## **2 Old George Place - Alterations to a Designated Property in the North Rosedale Heritage Conservation District - Refusal**

**Date:** June 13, 2025

**To:** Toronto Preservation Board

**From:** Senior Manager, Heritage Planning, Urban Design, City Planning

Photo of the north elevation of the existing building at 2 Old George Place (Google Maps, 2009)

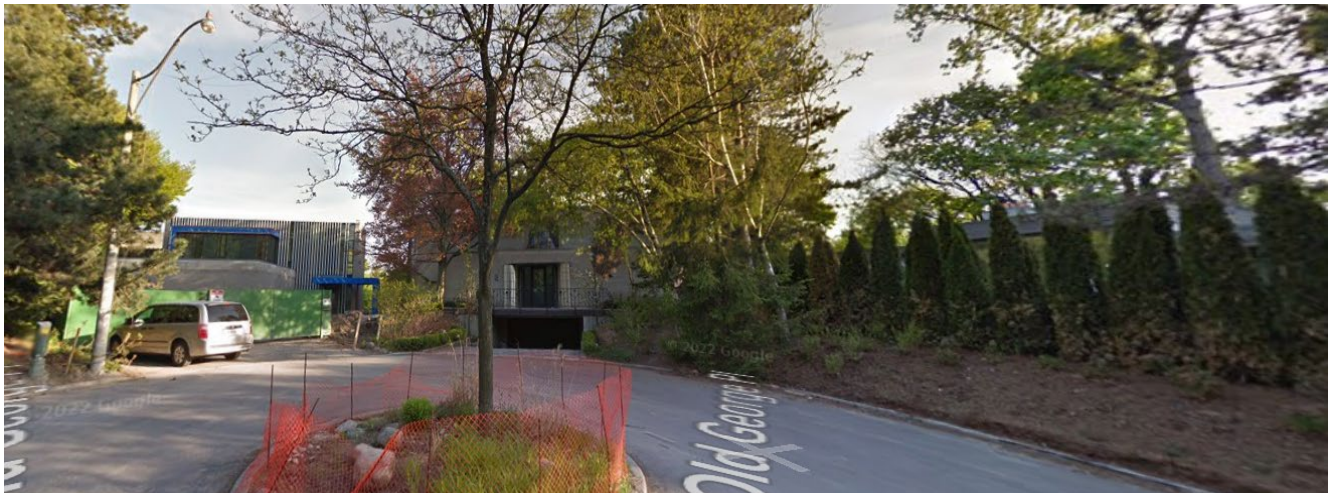
In addition, Old George Place is a cul-de-sac with a tight, unified architectural character. The proposed design and massing of the second and third storey addition with its stone posts, semi-circular apse, and projecting pitched roof is not compatible with the existing streetscape of Old George Place, which consists of Modernist-style homes with an apparent height of 1-2 storeys and flat roof forms when viewed from the street. Staff note that some of the existing homes on Old George Place have second storeys that were later additions which were significantly stepped back from the front facades, allowing the additions to have a height and form that is more in keeping with the character of the streetscape. The absence of step back for the proposed second storey addition exacerbates the overwhelming visual perception of massing of the proposed three-storey building. The overall effect is of an addition that has not been designed to have an apparent height and form and which is therefore incompatible with the streetscape of Old George Place.

Old George Place was one of the last developed areas in North Rosedale. The George Estate was subdivided into several properties and developed in the 1960s. All the houses were completed in a modern or post-modern architectural style. The NRHCD Plan includes statements of important heritage character that apply directly to this streetscape and property. The NRHCD Plan states "...many of these lots have striking aspects on the ravines and are designed to maximize the ravine topography (modern houses... are good examples of this). This topography presented an opportunity for architectural drama that the modernist architects of the 1960s and after pursued with aplomb." Section 5.0 of the NRHCD Plan states "Residential streets in any neighbourhood have a unique character. This character is a function of age, location, setbacks and lot size, periods of construction, landscape character, topography and socio-economic history". Old George Place maintains a unique and cohesive character, scale and form. As stated, this character is evidenced by its predominant era of development in the 1960s, its Modernist architectural styles, and the low-profile of homes.

Proposed front elevation of 2 Old George Place (Michael Bootsma Architect, 2025)

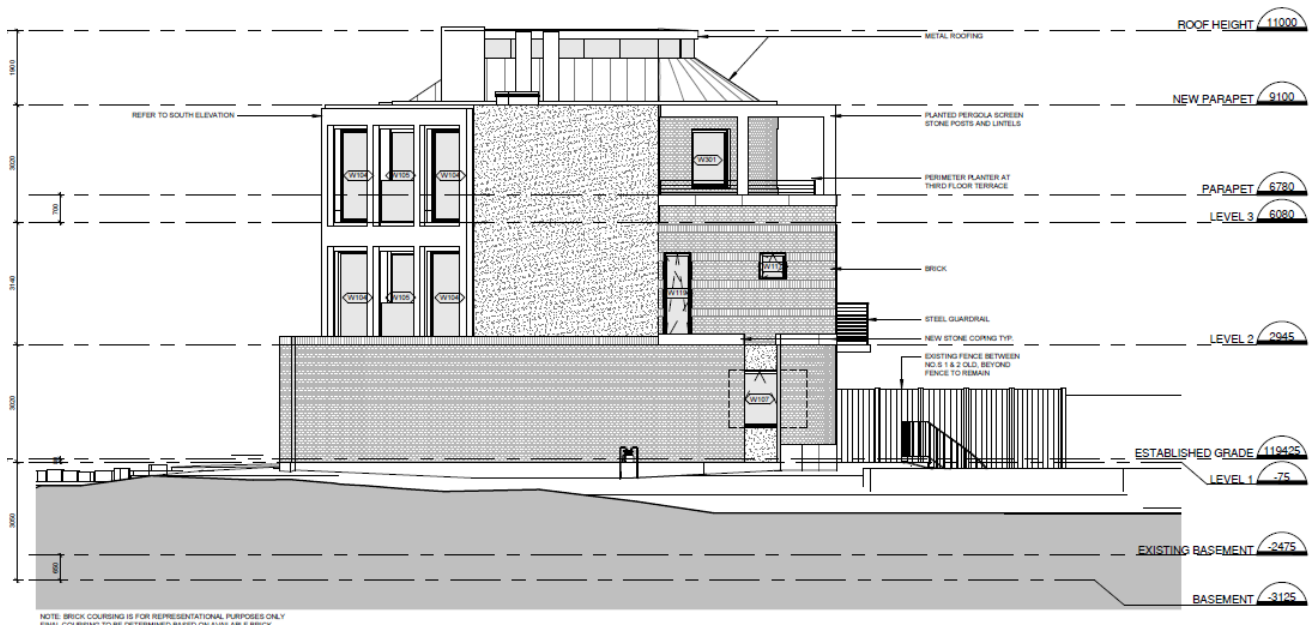
Heritage Planning Staff have reviewed the proposed additions and alterations to the existing building at 2 Old George Place which include the demolition of the existing second storey addition, and construction of a new two-storey addition with a "semi-circular apse" and "pitched roof" as noted in the submission package. The new second storey addition is proposed to be flush with the existing front facade. The third storey addition includes a semi-circular apse with a pitched roof and clerestory windows that will project above the third storey addition approximately 1.9 metres. The semi-circular apse is proposed to be stepped back from the front wall approximately 1.47 metres. As noted in the submitted drawings, the applicant is proposing to install stone posts connected by stone lintels at the third storey, which will be flush with the front and side facades and extend rearward to the top of the third storey addition where the pitched roof begins.

Staff are of the opinion that the application does not comply with the NRHCD Plan. First, the proposed height and absence of a step back adds to the visual perception of the new massing and therefore the proposed addition does not comply with the relevant policy in the NRHCD Plan which states "the roof profile and location of the eaves line or the roof parapet should be designed so that the apparent height and form of the roof is compatible with that of the streetscape".
